TECHNICAL SERVICE BULLETIN

Turn Signal Lamps Inoperative After LED Control Module Replacement

20-2322
15 September
2020

| Ford 2020 Police Interceptor Utility |

Figure 1 - Left side

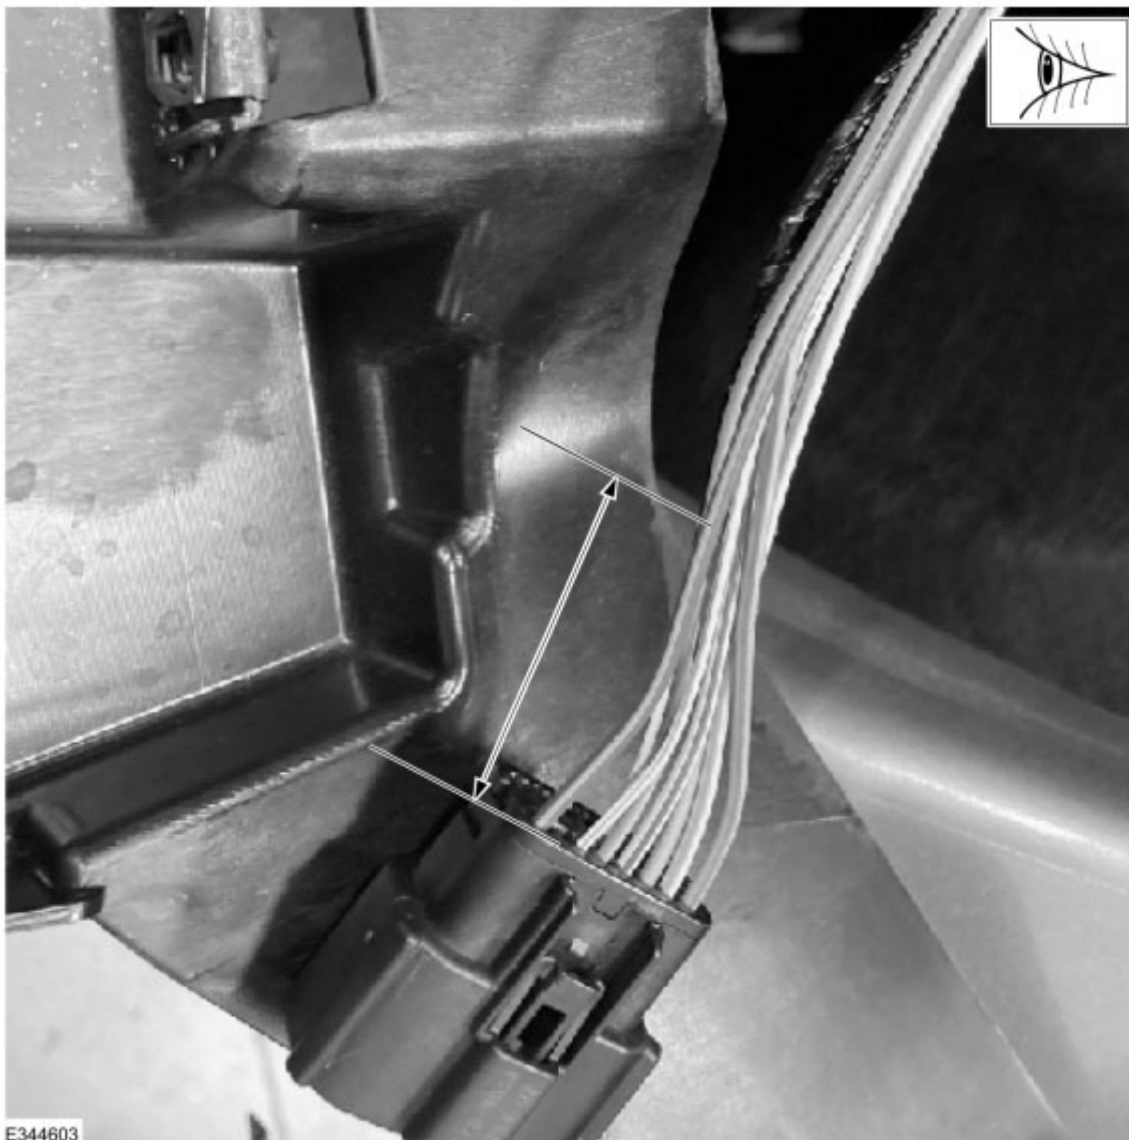
Issue: Some 2020 Police Interceptor Utility vehicles may exhibit inoperative turn signal lamps after replacement of the light emitting diode (LED) control module. This may be due to a lack of initialization caused by incomplete wiring circuits. To correct the condition, follow the Service Procedure to splice the needed circuits into the wiring harness of the affected side of the vehicle.

1. Remove the affected headlamp assembly. Refer to Workshop Manual (WSM), Section 417-01.
2. For vehicles where the left side is affected, update the left side wiring.
 - (1). Remove 2 wiring terminals from the wiring service pigtail connector.
 - (2). Install the terminals into connector C1284, pins 9 and 14. Refer to Wiring Diagram, Cell 085-4.
 - (3). Cut the wire to circuit GD120, pin 8 on connector C1284, 76.2 mm (3 in.) from the connector.
 - (4). Solder splice wires from pins 8, 9, and 14 to circuit GD120. Refer to Wiring Diagram, Cell 005. (Figure 1)
